# IFB-24-501 Addendum No.2: Answers to questions, additional scoping language, additive alternates, and site photos

# SITE #4 CARLSON PARK, ARCATA

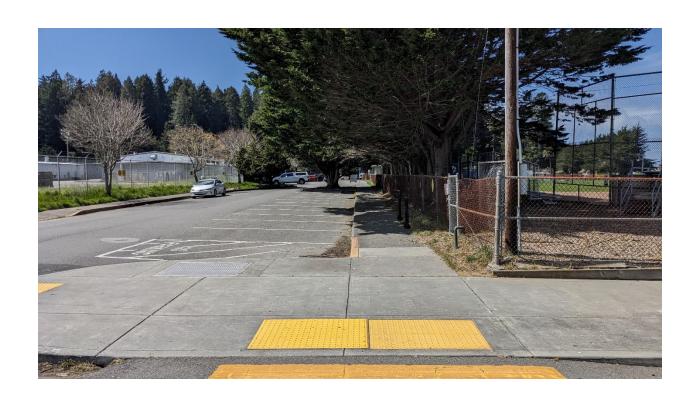
- 1. At site #4, Carlson Park, Bidder's scope of work will be delineated as follows:
  - a. City of Arcata will be responsible for:
    - i. Providing and installing the parking lot lights, poles, conduit, conductors, and pull boxes associated with them.
    - ii. Providing and installing the meter switchgear, backboard and 5' utility conduit stub toward utility pole mounted transformer
    - iii. Installing conduit from the meter switchgear to the charging station locations
    - iv. All paving of parking lot stalls
  - b. Bidders will be responsible for all other scope shown on plans.
